Access Compliance Report Public Rights-of-Way (Curb Ramps)

Intersection ID: 10198Main Street:FONTANA_AVCross Street:REMBERT_CTLocation:NEADA ID: 7914F2FD39A9Ramp Type:Combination1Initial Pass/Fail:FailOverall Compliance:NoSeverity Score:10

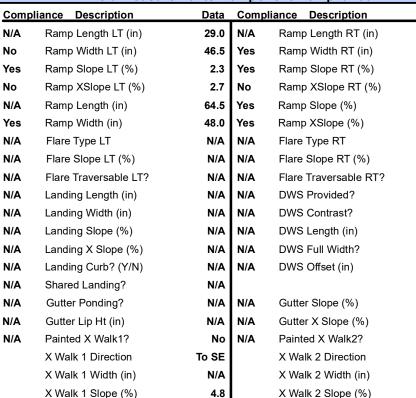
LT RP < 5%

Not Found, R304.5.1, R304.5.3

Remove & Replace Entire Ramp.
Remove & Replace Sidewalk.
